TOWN OF CORTLANDT PLANNING BOARD

Planning Board Work Session & Meeting Tuesday October 6, 2026

RE: **PB2026-12 - 44 Regina Avenue – Site Development Plans Self Storage**

LaBella has performed a review of the submittal for "Site Development Plan For Cortlandt Self Storage, LP" located at 44 Regina Avenue, Cortlandt Manor, New York.

SITE DEVELOPMENT PLAN

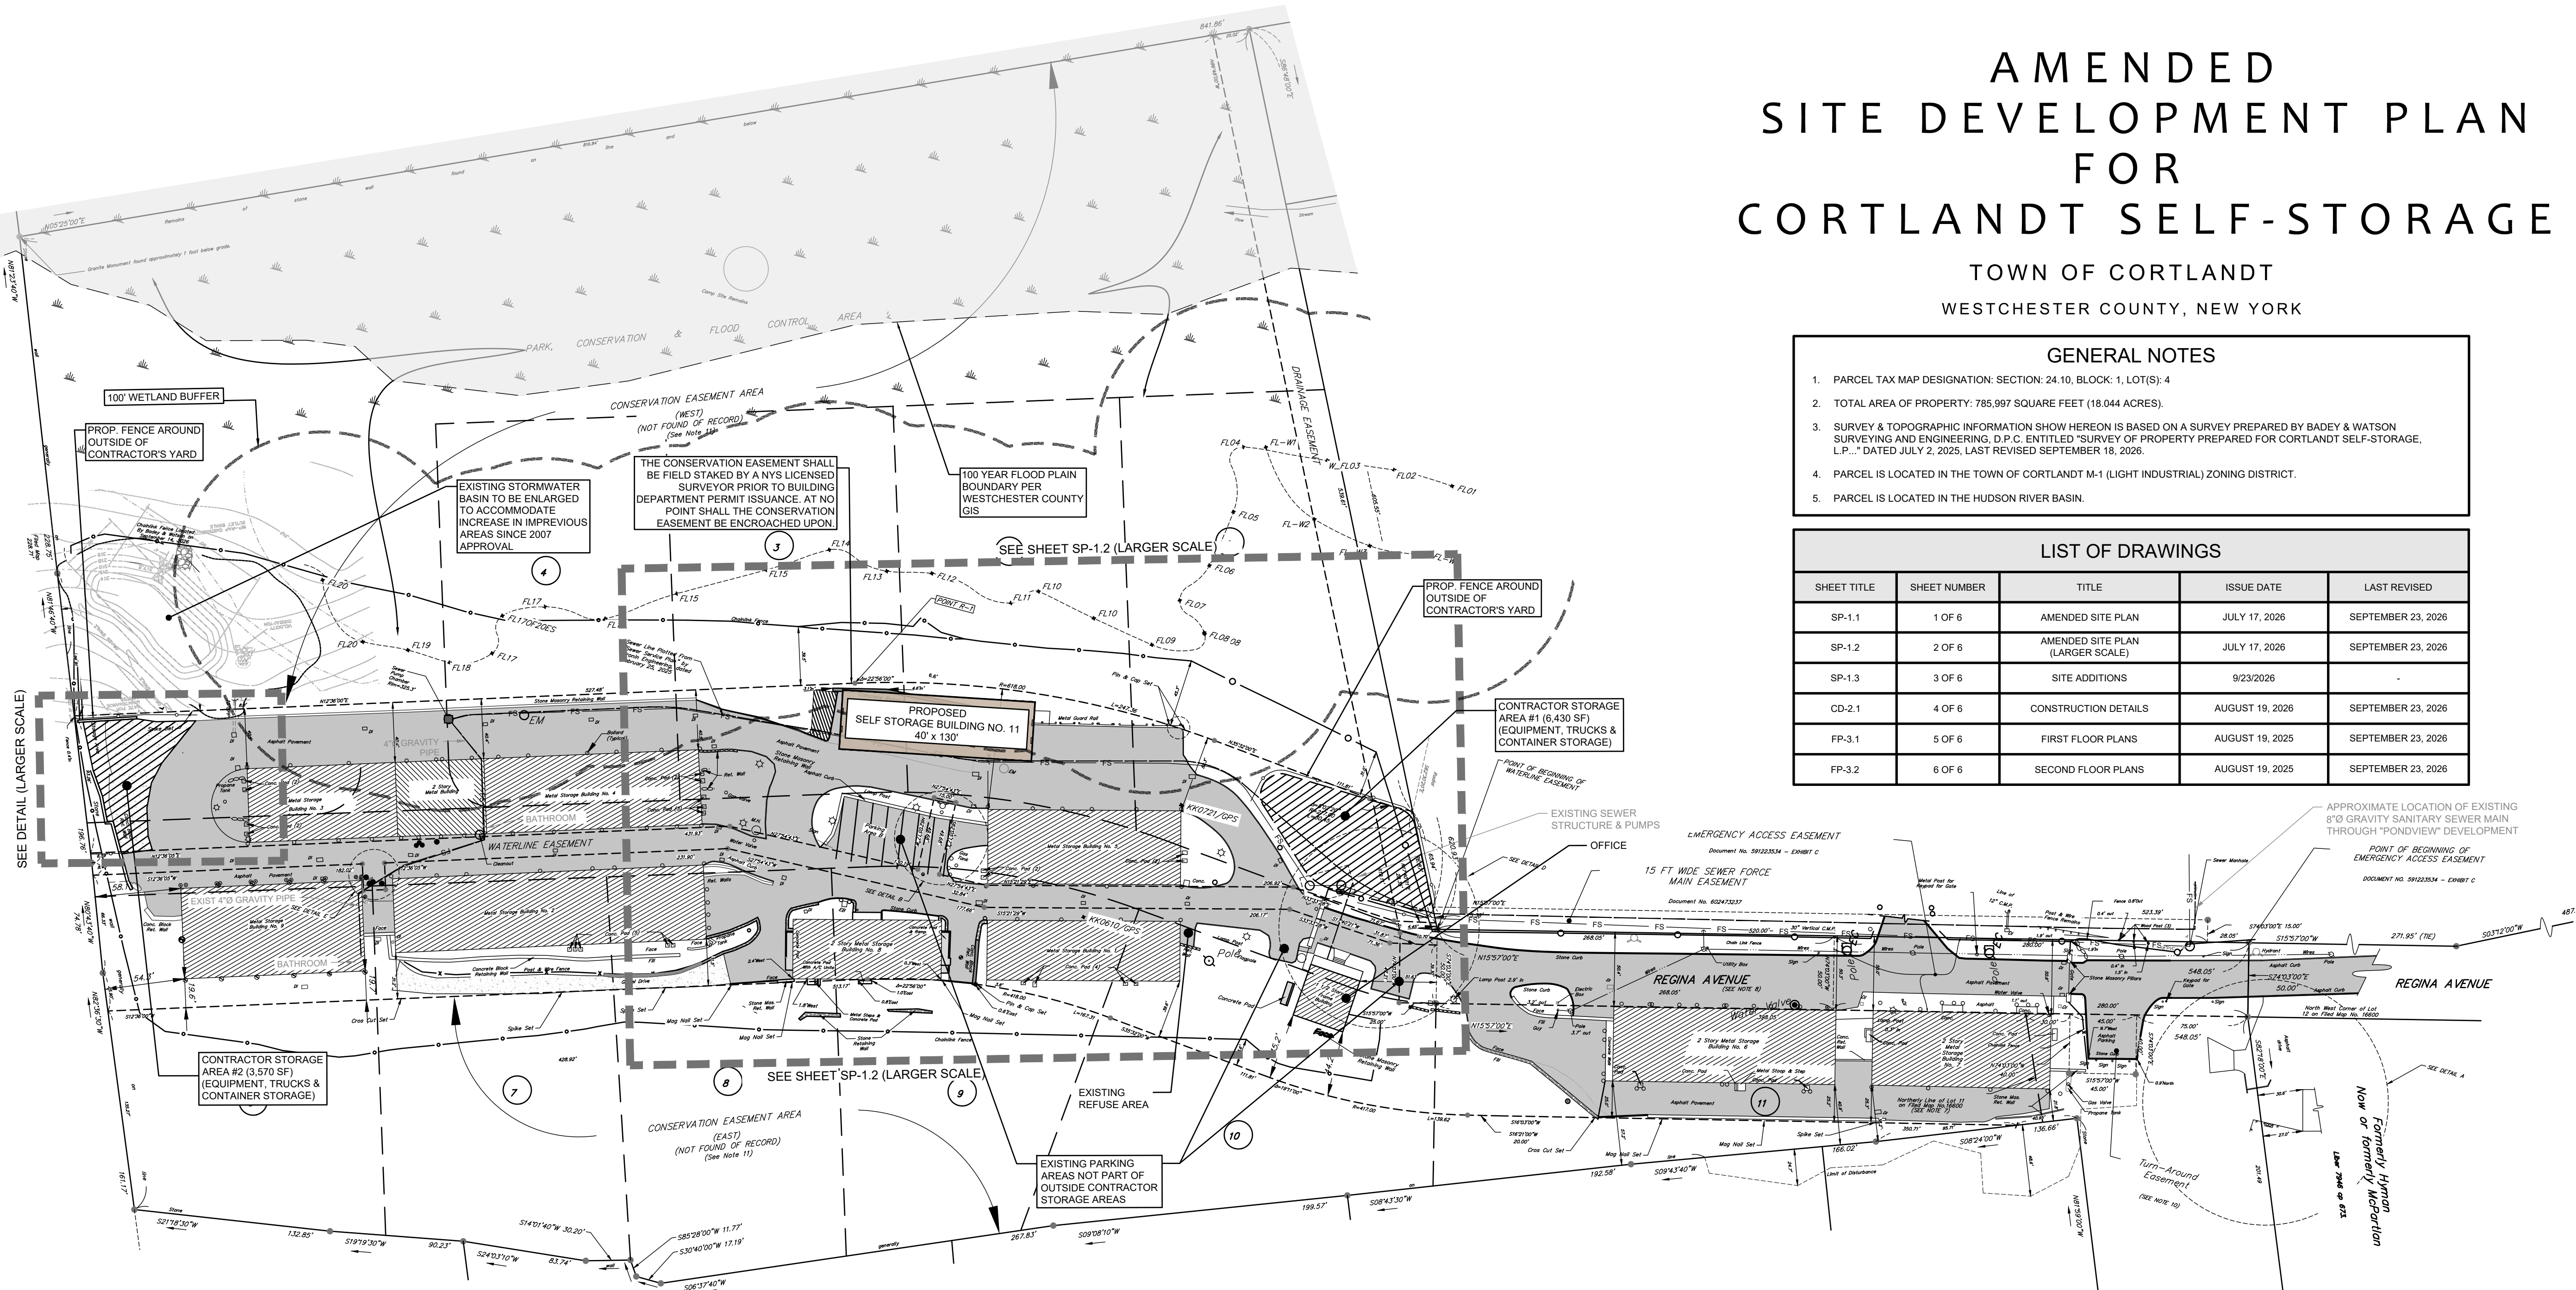
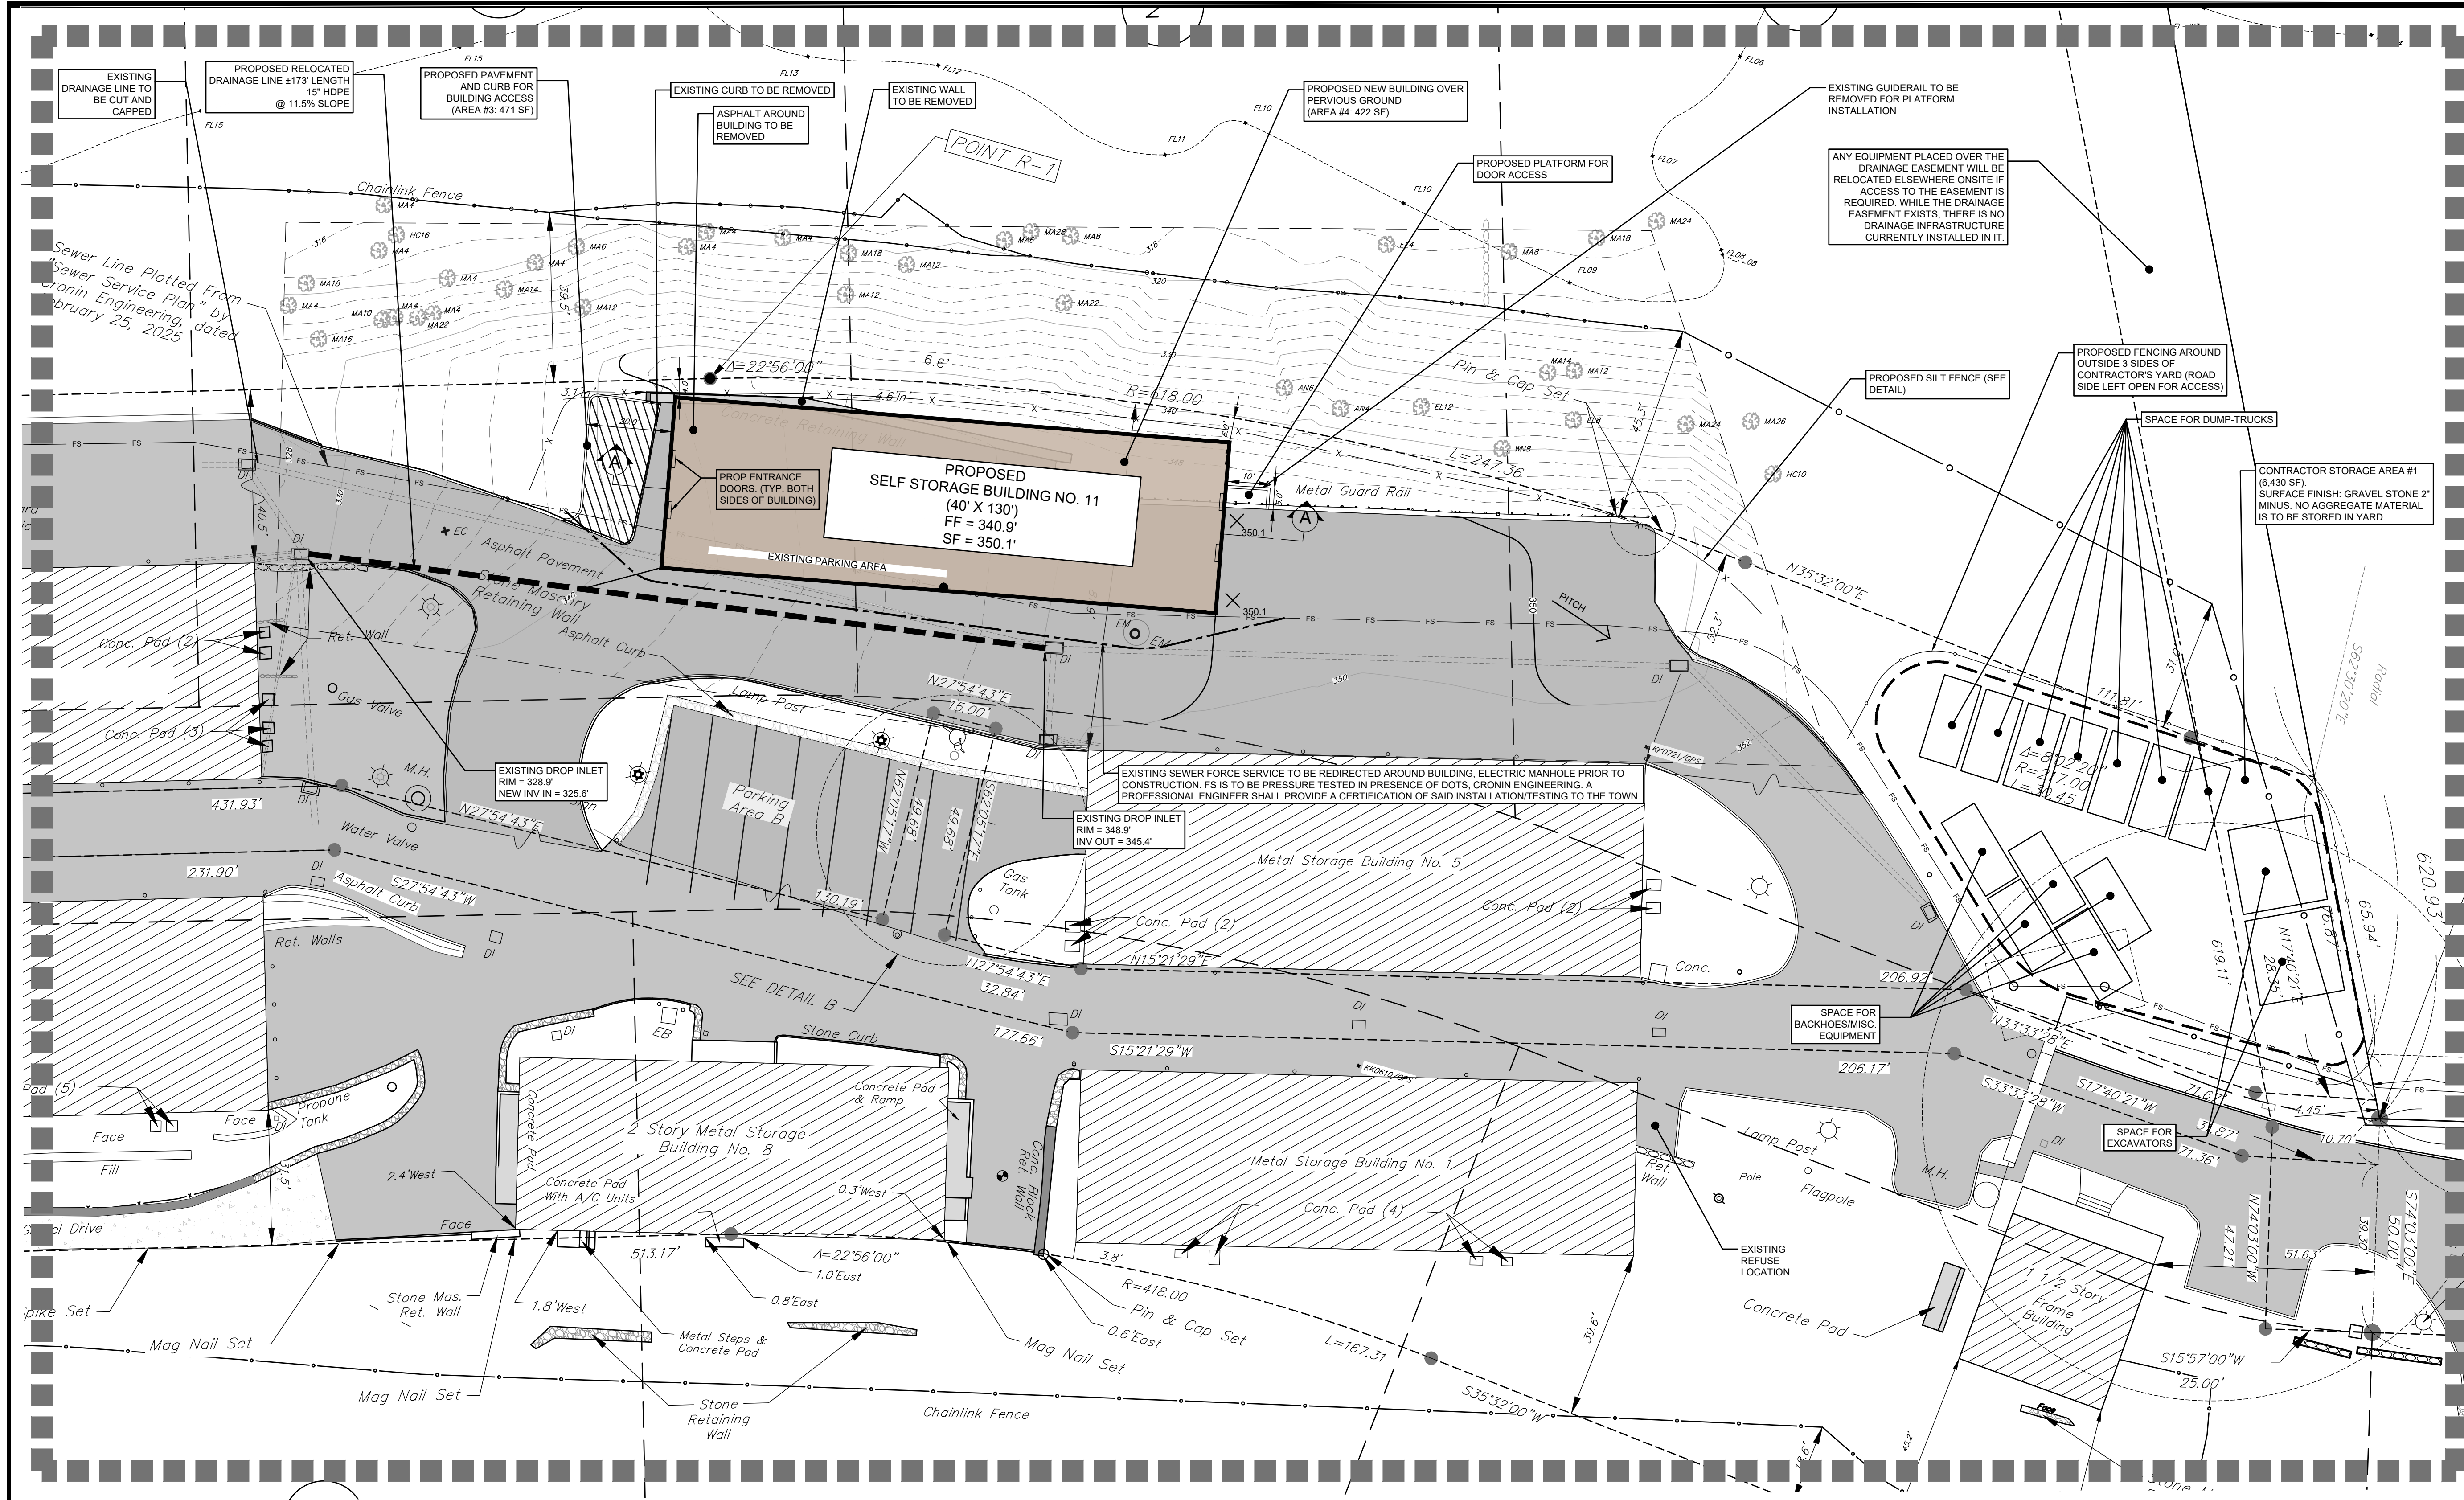
1. Extend the water line easement to encompass the hydrant near building 9.
2. Provide a dimensional bulk table for the site, legend, and Town Signature Block on the plans.
3. Note the previous site changes to the site.
4. Number all buildings.
